CLEARVIEW
TOWING MIRRORS

**FORD RANGER/
EVEREST/SUPER
DUTY
OAT (OUTSIDE
AMBIENT
TEMPERATURE)
SENSOR UPDATE
2026+ MODELS ONLY**

VERSION 1.0

View showing MY26 OAT Sensor in position

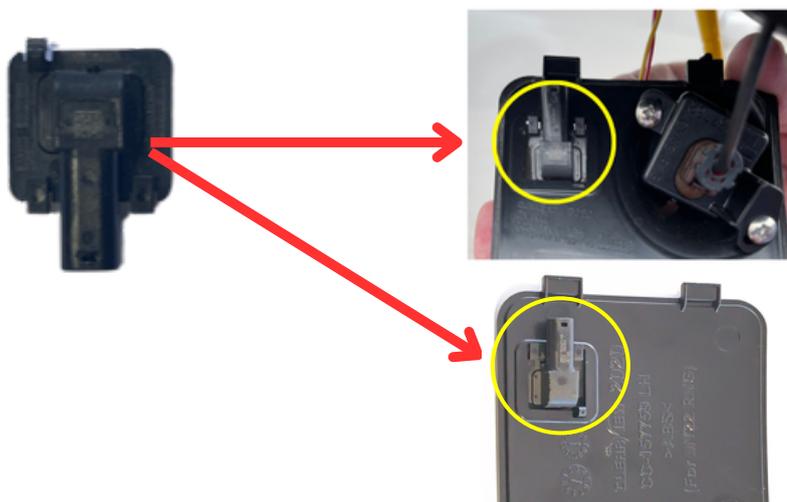
1. If your vehicle was built in NOV'17th 2025 or later, (please refer to your dealer), the OEM mirror will be fitted with a modified Outside Air Temperature(OAT) sensor. Refer to the images below.

2. If above image shown is the level of OAT in your vehicle, then skip step 8, on page 14 of the Clearview Towing Mirror Installation instructions. There is no need to remove the OAT from OEM Mirror as it cannot be re-used in the Clearview Towing Mirror.

3. The supplied Clearview Tow Mirror Box - CVNG-FD/CVC-FD will include a FORD compatible OAT Sensor (M2DZ 12A647 A) kit provided as below image.

3. Please proceed to Step 15 on page 25 of the Clearview Towing Mirror Installation instructions and Install the Ford-compatible OAT sensor (M2DZ 12A647 A) onto the LAP bracket of the towing mirror, with or without 360° camera provision, as applicable to your vehicle as shown in the image below.
